8. Lease Name and					
re. Type of completion. If thy adult Practiting S	ingle Zoi	ne Multiple Zone	DEEP ELEM 4 F	ED COM		
			778H			
2. Name of Operator EOG RESOURCES INCORPORATED				30-015-54084		
3a. Address 1111 BAGBY SKY LOBBY 2, HOUSTON, TX 77002	10. Field and Pool PURPLE SAGE;	, or Exploratory WOLFCAMP (GAS)

Eddy County, NM (NAD 83 NME) Deep Elem 4 Fed Com #778H

PECOS DISTRICT DRILLING CONDITIONS OF APPROVAL

577' FSL 855' FWL Section 4 T-26-S, R-31-E Proposed Wellbore Design B KB: 3,315' GL: 3,290'

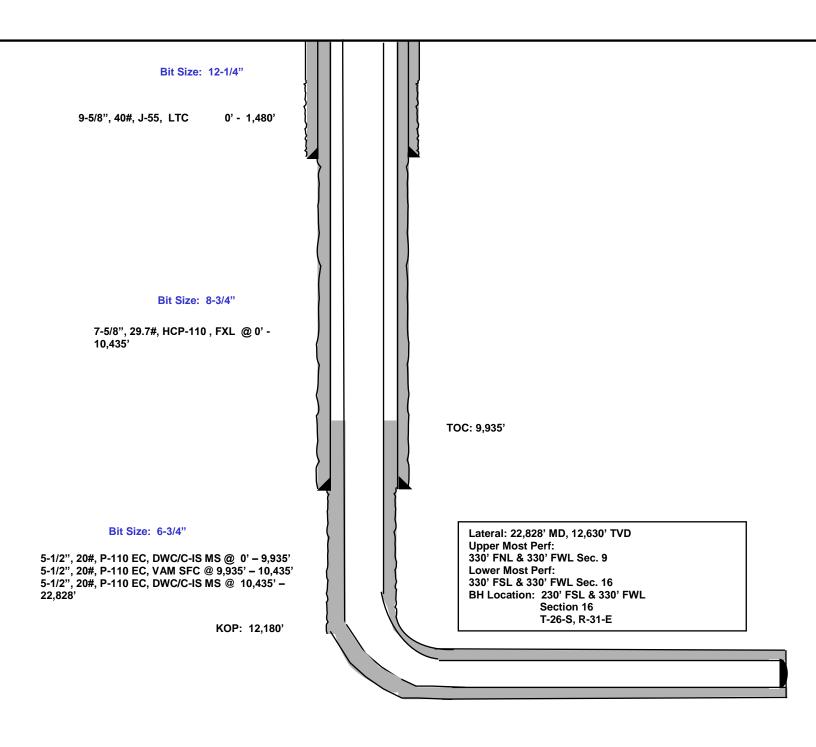
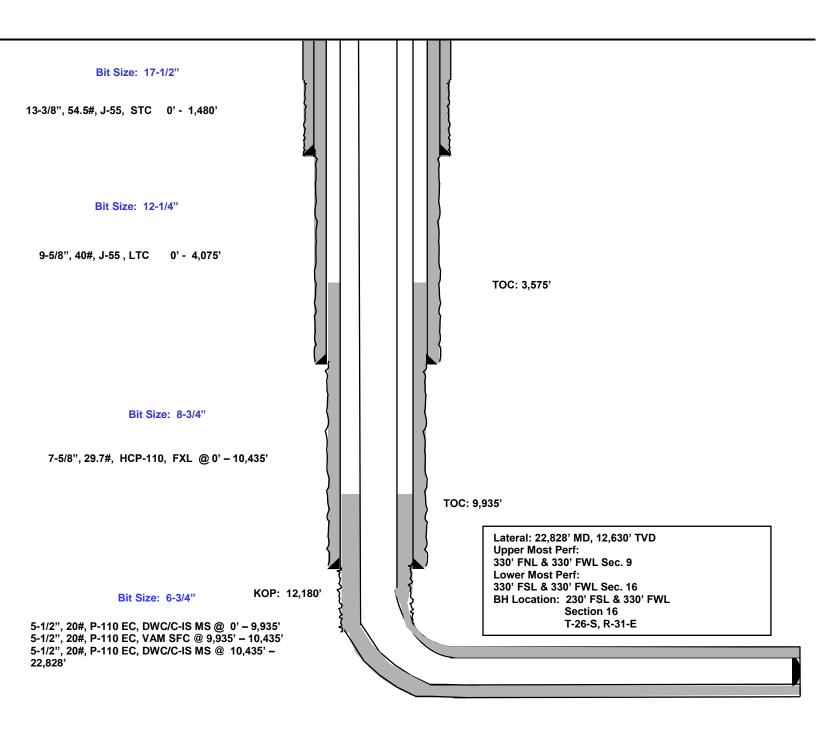
Operator is only approved for Design A. Design B is not to be utilized. If Design B is needed or any other change, please submit a NOI sundry to make the changes.
